YANMAR SERVICE NEWS

Subject	Protection Ring Size Change	No. : 12-2-G-03-011-O March 2013	
Engine Model	6EY18(A) L(W)	Use	Marine Aux.
		Engine Nos.	_____

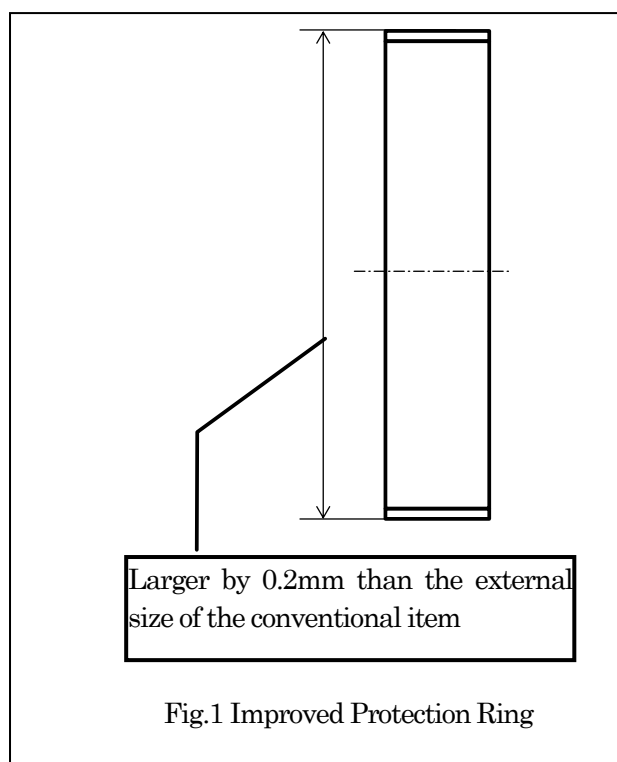
The outer diameter size of the protection ring was changed, and the part code was changed accordingly as described below.

In the present change, the outer diameter of protection ring was made larger than that of the conventional protection ring in an aim to control carbon deposit. We have verified that there was no problem with the use of the changed protection ring in place of the conventional protection ring. This specification will be our standard specification hereafter.

Upon the engine servicing opportunities, check the protection ring according to the maintenance instructions given in the operation manual. If the ring has been worn exceeding the limit, replace the ring.

Old	New
Part Code	146623-01120	146623-01121
